Access Compliance Report

Public Rights-of-Way

Intersection ID: 11910	Main Street: E_W_T_HARRIS_BV	Cross Street: ROBINSON_CHURCH_RD	Location: N
ADA ID: F549A0B44EDF	Ramp Type: PerpDiag	Initial Pass/Fail: Fail	Overall Compliance: No
		Severity Score: 25

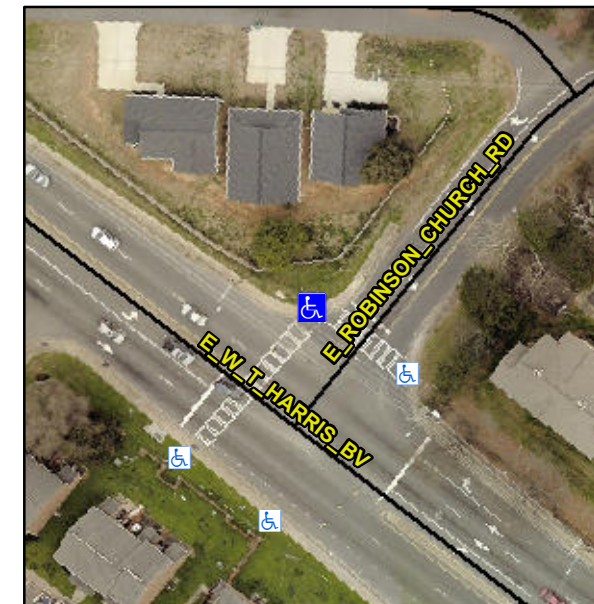
Not Found, R304.2.2, R304.5.3

Compliance	Description	Data	Compliance	Description	Data
N/A	Ramp Length (in)	57.0	No	Ramp Slope (%)	10.6
Yes	Ramp Width (in)	48.0	No	Ramp XSlope (%)	5.5
N/A	Flare Type LT	N/A	N/A	Flare Type RT	N/A
N/A	Flare Slope LT (%)	N/A	N/A	Flare Slope RT (%)	N/A
N/A	Flare Traversable LT?	N/A	N/A	Flare Traversable RT?	N/A
N/A	Landing Length (in)	N/A	N/A	DWS Provided?	N/A
N/A	Landing Width (in)	N/A	N/A	DWS Contrast?	N/A
N/A	Landing Slope (%)	N/A	N/A	DWS Length (in)	N/A
N/A	Landing X Slope (%)	N/A	N/A	DWS Full Width?	N/A
N/A	Landing Curb? (Y/N)	N/A	N/A	DWS Offset (in)	N/A
N/A	Shared Landing?	N/A			
N/A	Gutter Ponding?	N/A	N/A	Gutter Slope (%)	N/A
N/A	Gutter Lip Ht (in)	N/A	N/A	Gutter X Slope (%)	N/A
N/A	Painted X Walk1?	Yes	N/A	Painted X Walk2?	Yes
	X Walk 1 Direction	To SW		X Walk 2 Direction	To SE
N/A	X Walk 1 Width (in)	111.0	N/A	X Walk 2 Width (in)	118.0
	X Walk 1 Slope (%)	5.3		X Walk 2 Slope (%)	5.0
	X Walk 1 X Slope (%)	1.5		X Walk 2 X Slope (%)	5.5

Remove & Replace Curb Ramp With Two New Directional Ramps or Equivalent.
